**Planning Department
Transportation Development Services**

**Re: McDonalds, 6300 San Mateo Blvd.
Traffic Circulation Layout**
Architect's Stamp dated 11-05-14 (E18-DO19C)

Based upon the information provided in your submittal received 11-07-14, the above referenced plan cannot be approved for Building Permit until the following comments are addressed:

MCDONALD'S TRAFFIC CIRCULATION
6300 SAN MATEO BLVD NE PLAN LAYOUT

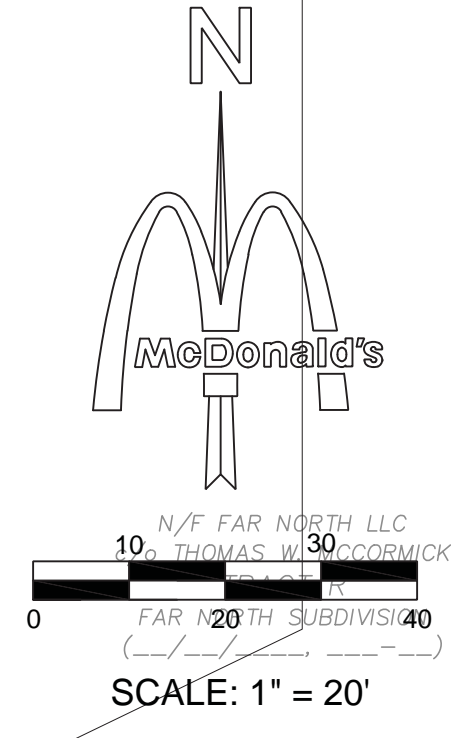
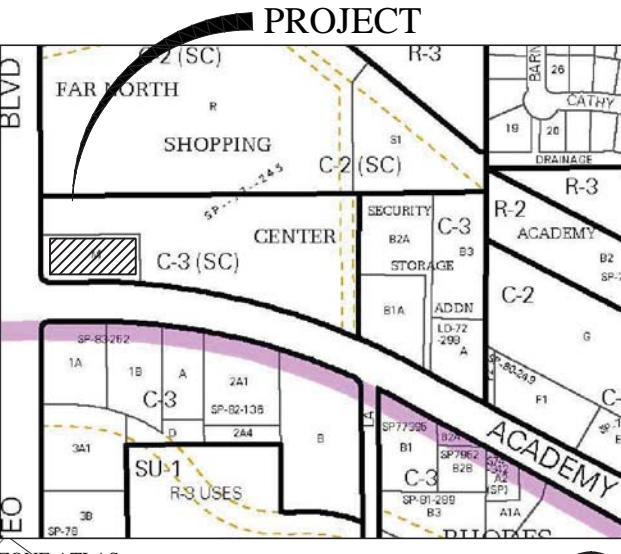
1. Label the McDonald's building as existing. Label width of existing sidewalk along San Mateo Boulevard. If some of the existing curb on the site is to remain, label the existing curb and curb height. (The curb height should be between 6 inches and 8 inches.)

2. List the width for all parking spaces. The minimum width for the parking spaces should be 8.5 feet. Also label the width of the handicap space on the south side of the parking lot.

3. The handicap accessible spaces must include an 8-foot wide van access aisle. Currently, the aisle shown is only 5 feet. Also, label the striping for the handicap accessible aisle and pathway.

4. Include an ADA van accessible sign. This sign must have the required language per 66-7-352.4C NMSA 1978 **"Violators Are Subject to a Fine and/or Towing."** (Provide sign detail on Sheet C10.1 as called out by Keyed Note 7 on the plan sheet.)

5. The 8-foot wide ADA access aisle shall have the words **"NO PARKING"** in capital letters, each of which shall be at least one foot high and at least two inches wide, placed at the rear of the parking space so as to be close to where an adjacent vehicle's rear tire would be placed. (66-1-4.1.B NMSA 1978)

6. Per the DPM, a minimum 6-foot wide ADA accessible pedestrian pathway is required from the public sidewalk to the building entrances. Please widen the existing handicap accessible pathway shown tying into the existing sidewalk at

7. A 6-inch to 8-inch high curb is required to separate the driving area and parking lot from the sidewalk and landscaped areas. Label the new curb as 6 inches or 8 inches.
8. Label both existing and proposed asphalt for the new parking lot.
9. Show the queue length for the drive-thru.
